**Medway Planning & Economic Development Board
Meeting**

Phytopia Public Hearing Continuation
Major Site Plan, Reduced Parking
Special Permit and Groundwater
Protection Special Permit

RE: **Public Hearing Continuation for Phytopia, Inc - Major Site Plan, Groundwater Protection Special Permit, and Reduced Parking Special Permit**
Continuation Date -- Tuesday, July 12, 2022

**Re: Phytopia Inc.
 Major Site Plan Review
 6 Industrial Park Road
 Medway, Massachusetts**

DRAWING: C1.1

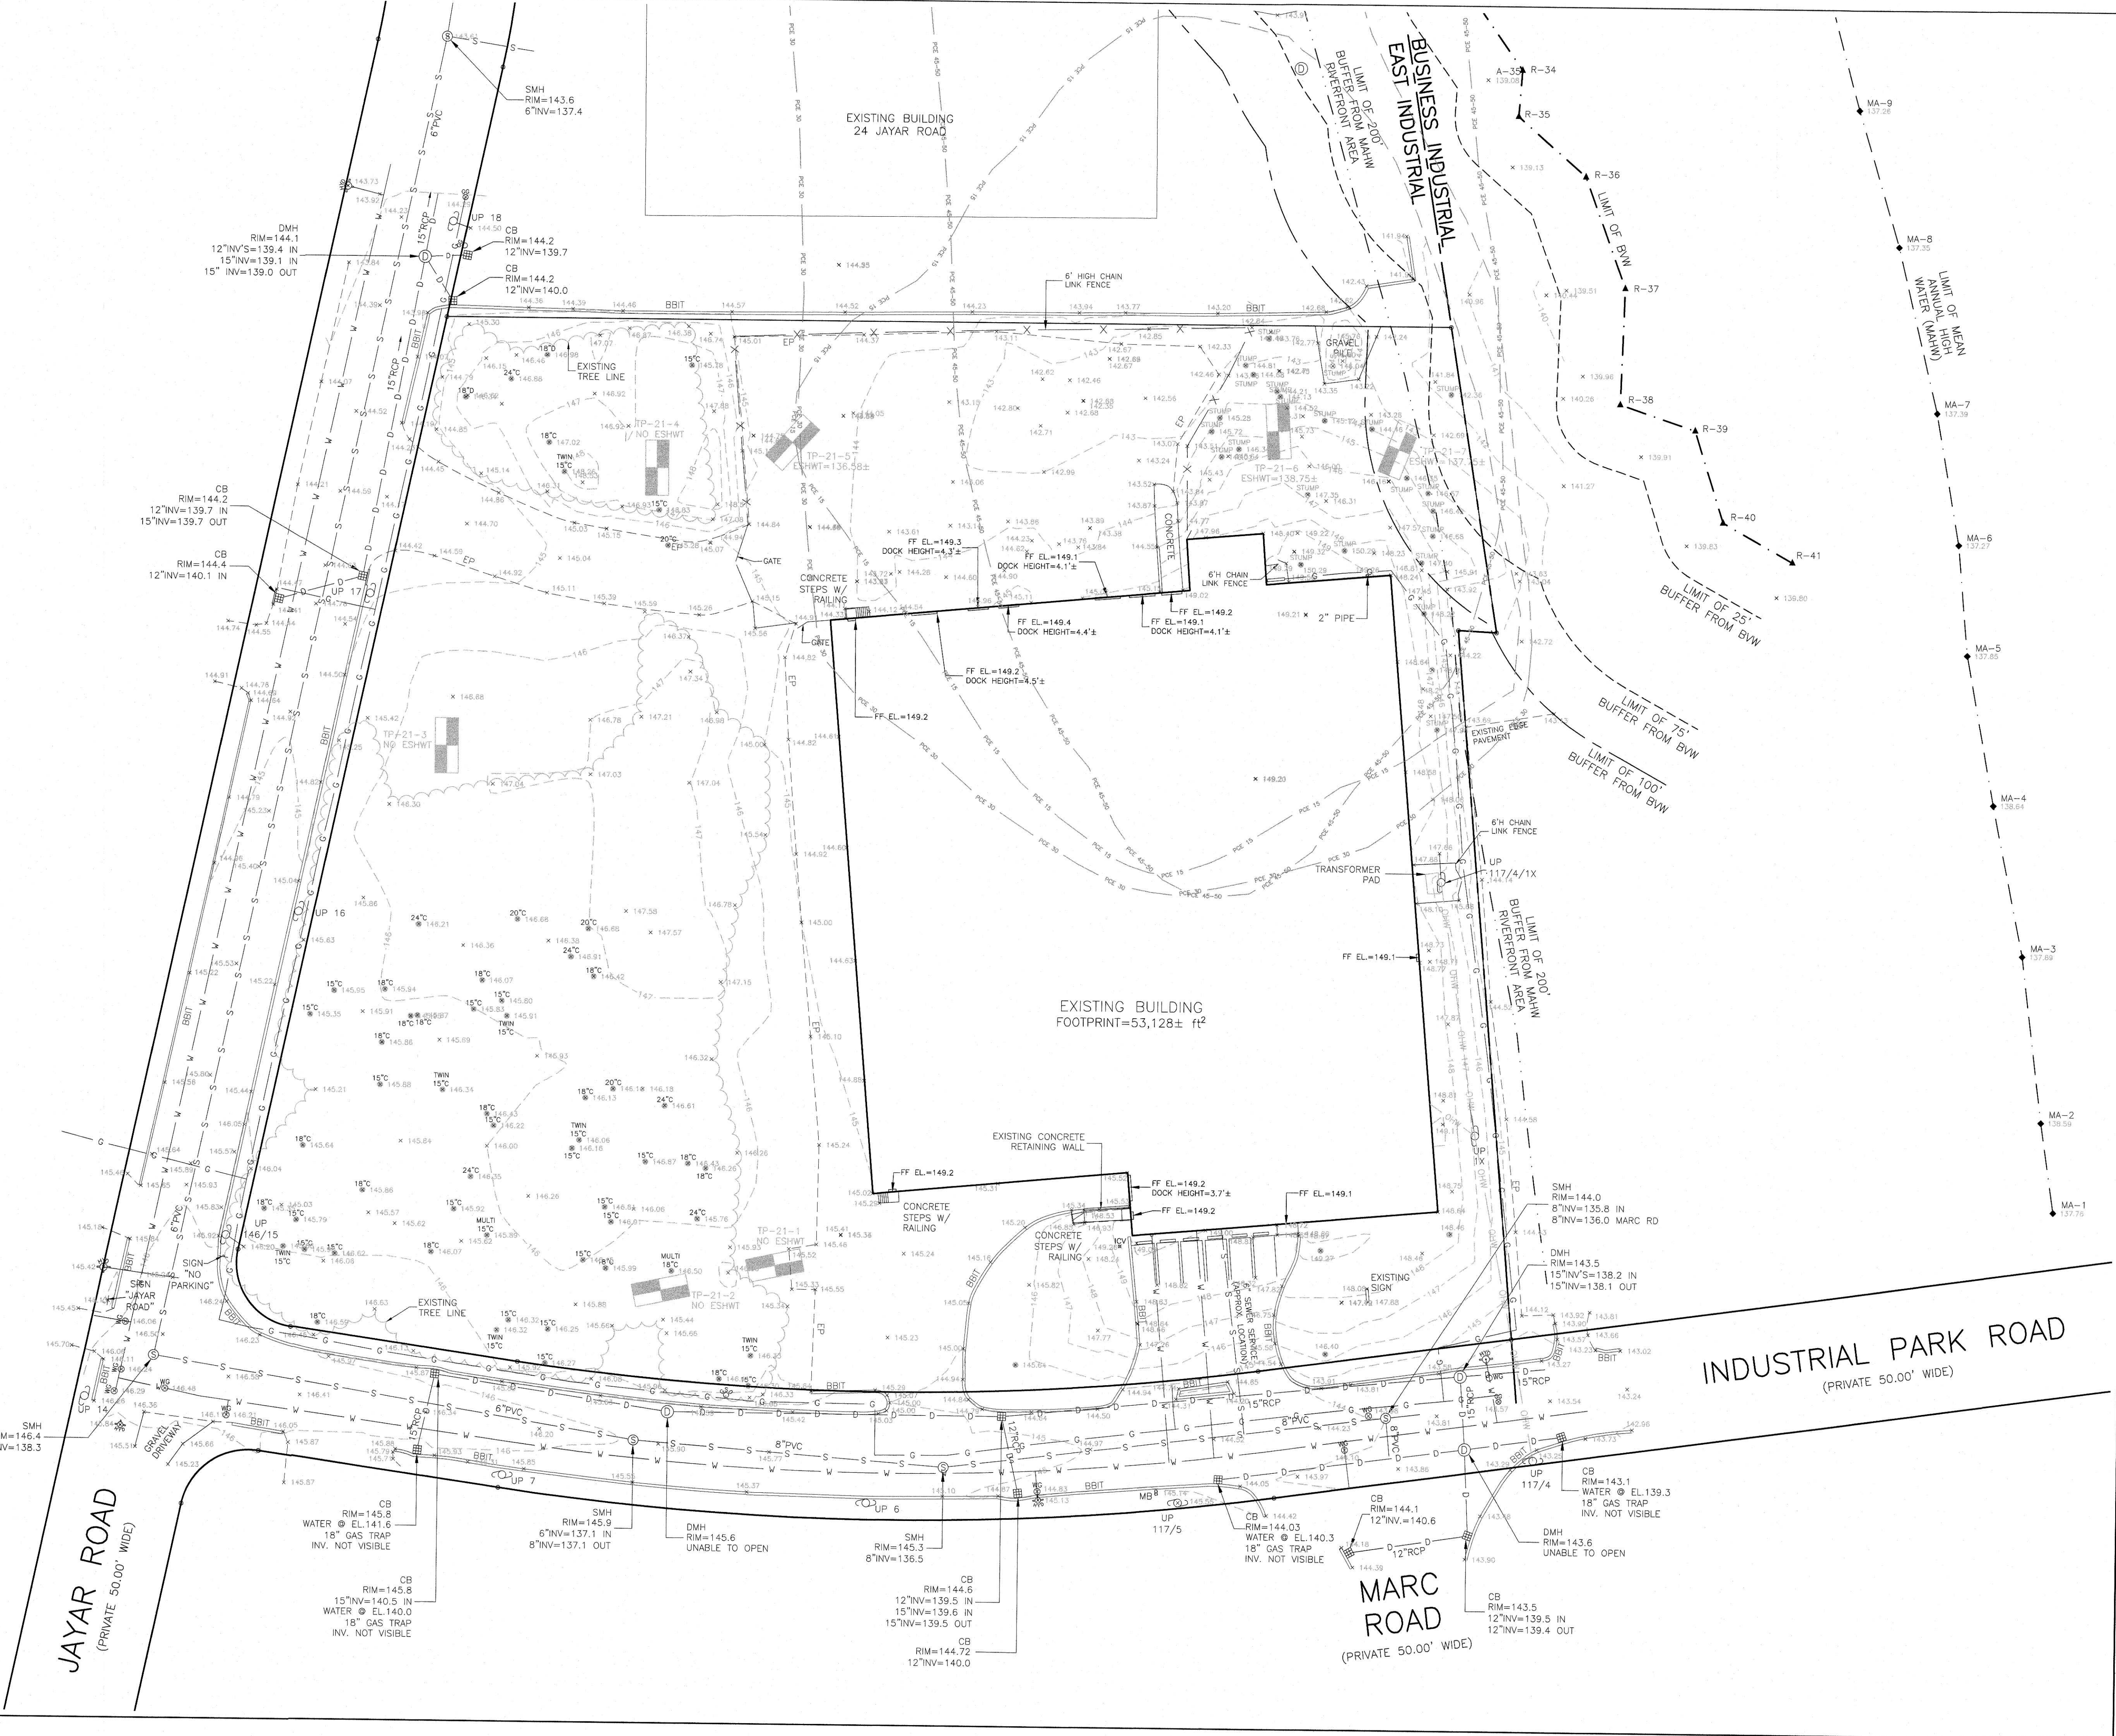
6. Cover sheet has not been provided in the Plans. However, applicable cover sheet information is provided on the Site Context Sheet/Location Plan. A list of requested waivers should be added to the sheet once approved by the Board. (Ch. 200 §204-5.A)

- *WSE 10/12/21 Response: A cover sheet with a list of waivers has been provided, see sheet 1 of 10.*
 - **TT 10/27/21 Update: The list of requested waivers has not been included on the Cover Sheet.**

- *WSE 4/12/22 Response: The list of requested waivers has been added to Sheet 1, the Cover Sheet.*
 - **TT 4/22/22 Update: In our opinion, this comment is resolved.**
